## Mercury Racing Gen III Cool Fuel Module

Models Covered	Serial Number Or Year
520	0M970122–0M971747
540	0M970845–0M971580

#### Cool Fuel module

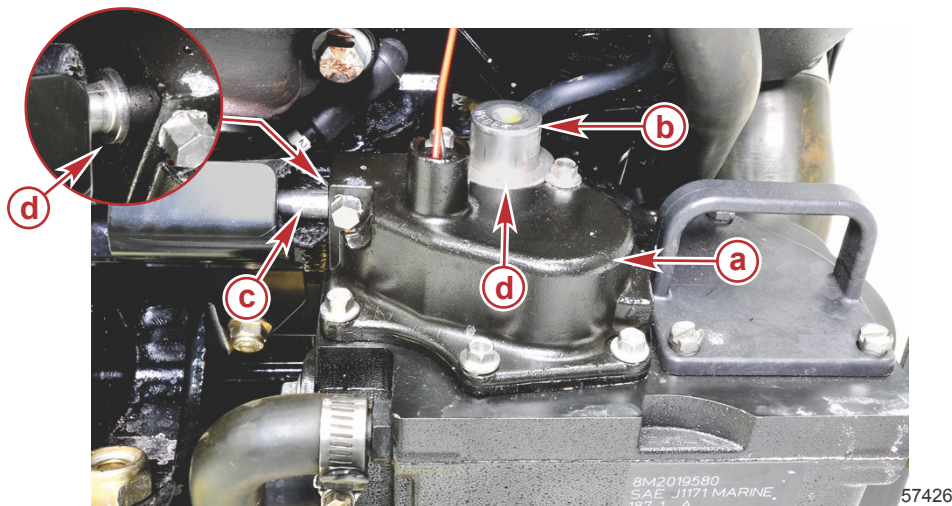
A situation has been identified whereby fuel may weep or very slowly leak from either the area under the fuel pressure regulator or at the joint between the Gen III Cool Fuel module and the discharge fuel line that carries fuel to the fuel rail, in the products listed above.

If you encounter the above condition, thoroughly inspect the areas around the fuel pressure regulator, discharge fuel line, and below the Gen III Cool Fuel module for the accumulation of fuel residue.

- a** - Cool Fuel module top cover
- b** - Fuel pressure regulator
- c** - Discharge fuel line
- d** - Inspection points

If signs of fuel weepage are observed at the inspection points, replace the Gen III Cool Fuel module top cover and seal, fuel pressure regulator, and the discharge fuel line quad ring.

The new Gen III Cool Fuel module top cover is now anodized.
